# Ferrari North America, Inc.

U.S.A. RECALL CAMPAIGN NO. C24000067

# LH And RH Bowden Cable Replacement And Layout Review

**SUBJECT:** Recall Campaign No. C24000067

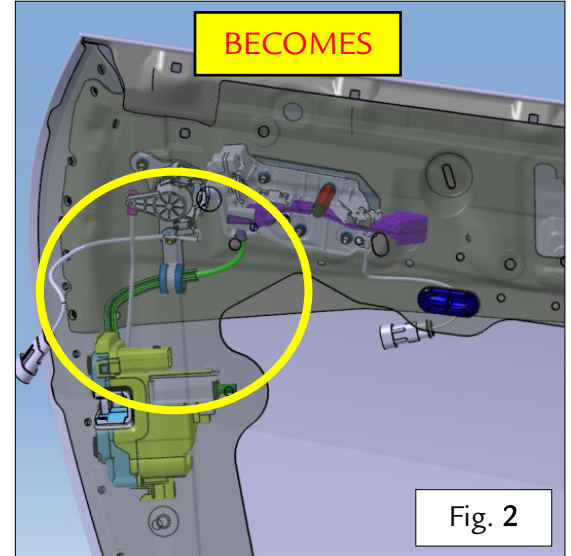
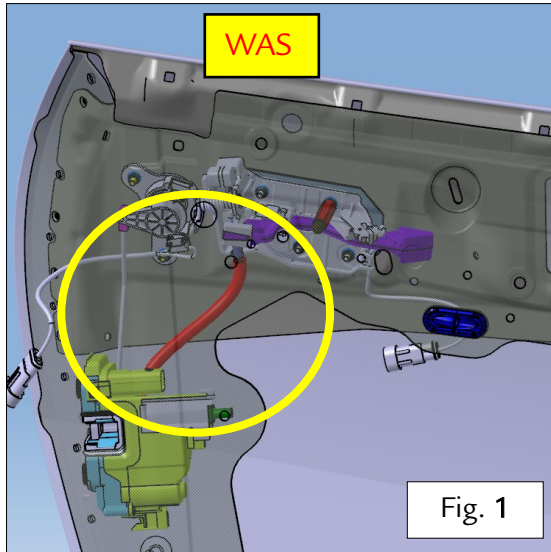
The repair, which applies to both the driver side and the passenger side doors, involves (Fig. 1 and 2):

- Replacing the cable with a longer one (50 mm longer);
- Making the cable layout fool proof with a bracket fastened to the pawl housing;
- Replacing the door lock

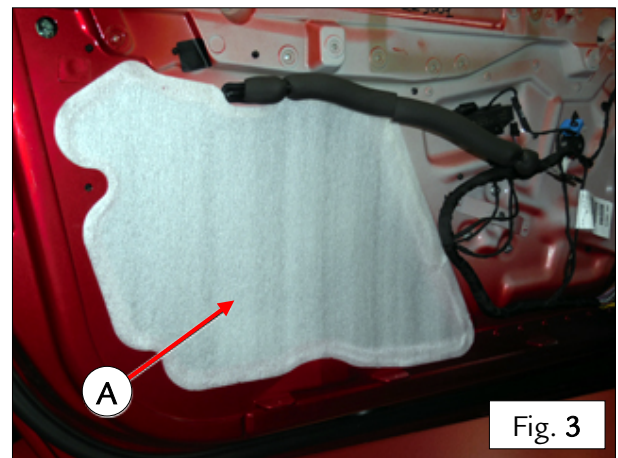
1. Remove the door panel (as described in paragraph E3.09 “Removing door panels” in the Workshop Manual);
2. Remove the rear waterproof liner sheet (A) – Fig.3;

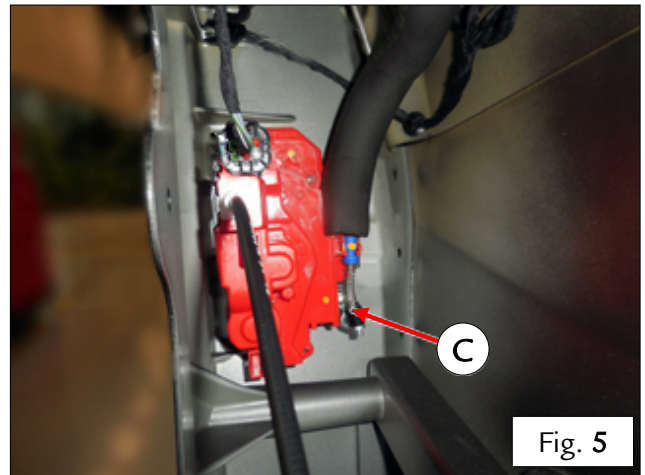
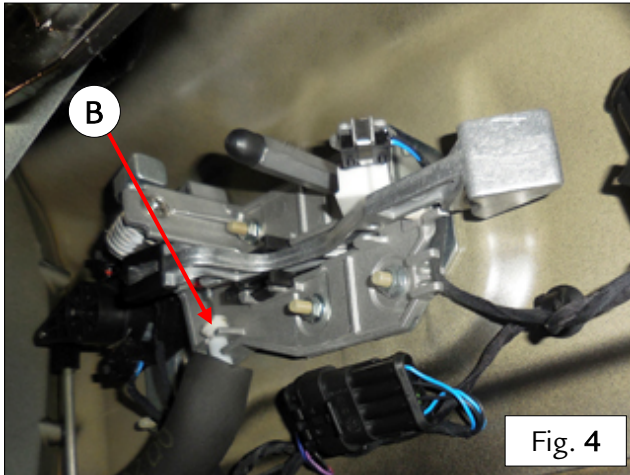
3. Detach the end of the Bowden cable on the external handle side (B, Fig.4) and door lock side (C, Fig.5);

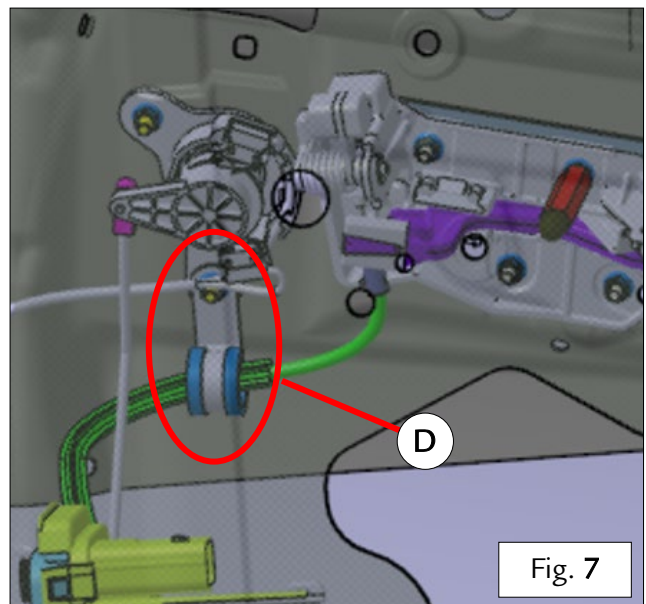
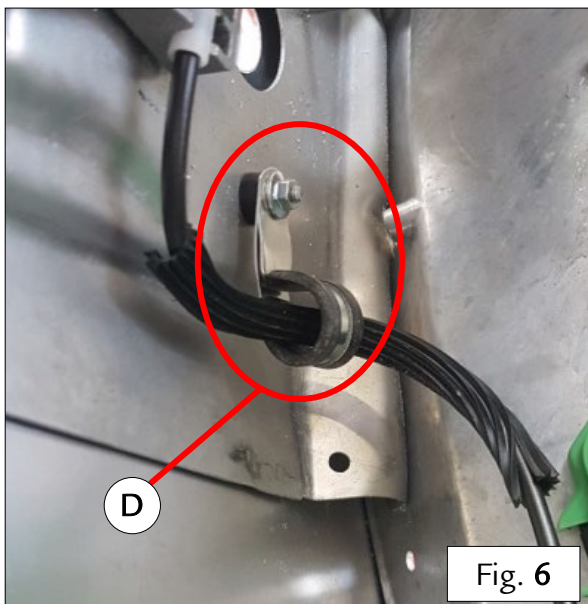
4. Using the existing fastening for the pawl housing, fit the bracket (D), and tighten the nut to a torque of 2 Nm, class B - (Fig. 6 and 7).

**Note:** Note that, in order to show the correct position of the bracket, the pawl housing is not shown in Figures 6 and 8.

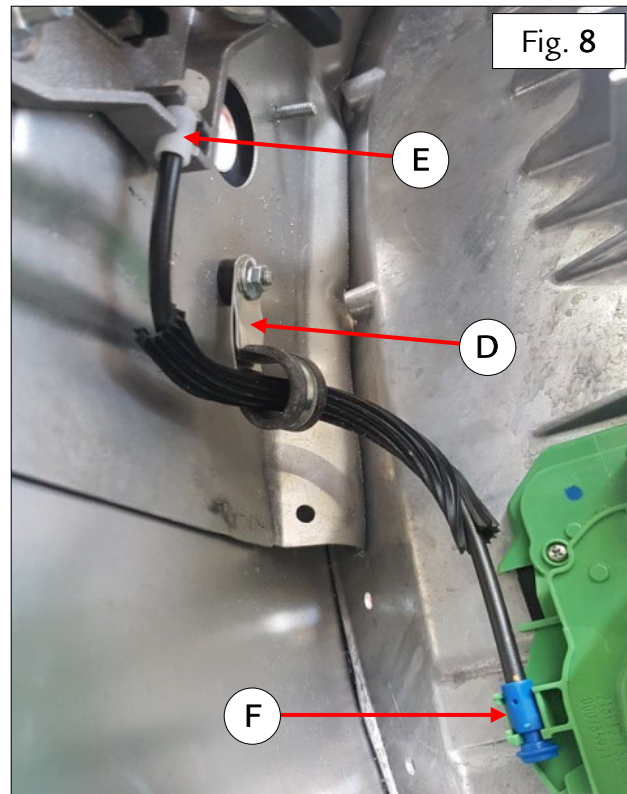
6. Attach the Bowden cable on the external handle side (E) and the door lock side (F), and pass it through the bracket (D) which has previously been installed - (Fig. 8). **Note:** the bracket does not restrain the Bowden cable but guides its lay-out when the external handle is used.

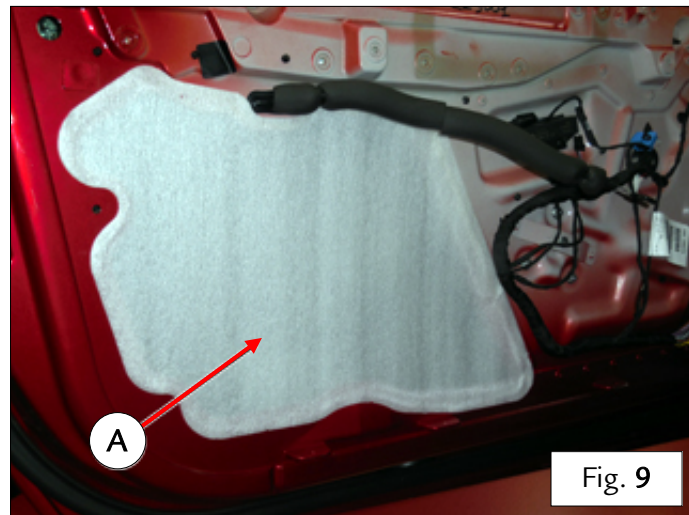
7. Replace the rear waterproof liner sheet (A) with a new one - Fig.9;
